# Work Order ID 80239

Item ID: D2580-1 Accept **\*N900040100\*** Setup Start **\*NS1\***  
 Revision ID: Stop **\*NS2\***  
 Item Name: 205 Skidtube bent detail  
 Start Date: 15/02/2012 Start Qty: 2.00 **\*2\*** Cust Item ID:  
 Required Date: 17/02/2012 Req'd Qty: 2.00 **\*2\*** Customer:  
 Reference:

DRAWING NO. D2580	TITLE 205 SKIDTUBE ASSEMBLY	REV. E	DART AEROSPACE LTD ENGINEERING ORDER		D.E.O. NO. D2580-E-1	SHEET NO. SHEET 1 OF 1	SCALE NTS
DRAWN <i>UP</i>	CHECKED <i>ASS</i>	MFG. APPR. <i>EC</i>	APPROVED <i>[Signature]</i>		DE APPR. <i>[Signature]</i>		
DATE 11.12.13	DATE 11.12.13	DATE 11.12.13	DATE 11.12.13		DATE 11.12.13

CHANGE ALL C'BORED WELDED CROSSBOLT SPACERS TO SWAGED SPACERS

**SECTION B-B, F-F, I-I**  
NOT TO SCALE

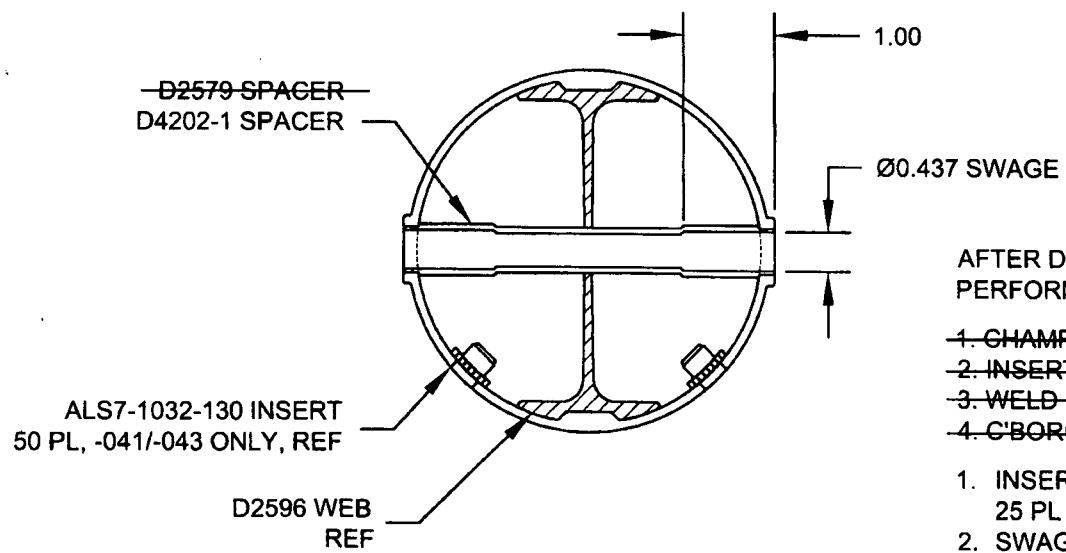
PARTS LIST IS AMENDED AS FOLLOWS:

WAS

QTY	QTY	QTY	PART NUMBER	DESCRIPTION
-041	-045	-047		
20	24	25	D2579	CROSS BOLT SPACER

IS

4		* D2579	CROSS BOLT SPACER
20	20	25	D4202-1	SPACER

**\* FOR -045 SKIDTUBE ONLY:**

WELD 4X D2579 SPACERS PER DWG  
IN LOCATIONS MARKED "NO C'BORE".  
REF SHEET 4 OF DWG.

SECTION B-B, SECTION F-F, & SECTION I-I ARE AMENDED AS FOLLOWS  
FOR ALL HOLES THAT WERE ORIGINALLY C'BORED:

AFTER DRILLING AND BENDING ASSEMBLY  
PERFORM THE FOLLOWING FOR Ø0.508 HOLES ONLY:

1. CHAMFER HOLE 0.050 X 45°
2. INSERT D2579 SPACER (20 PLACES)
3. WELD INTO PLACE AND GRIND FLUSH
4. C'BORE D2579 SPACER TO Ø0.437 X 1.00 DEEP

1. INSERT D4202-1 SPACER, 20 PL (-041) OR 20 PL (-045) OR 25 PL (-047)
2. SWAGE TO Ø0.437 X 1.00 DEEP PER QSI 002
3. TRIM / GRIND FLUSH PER QSI 002
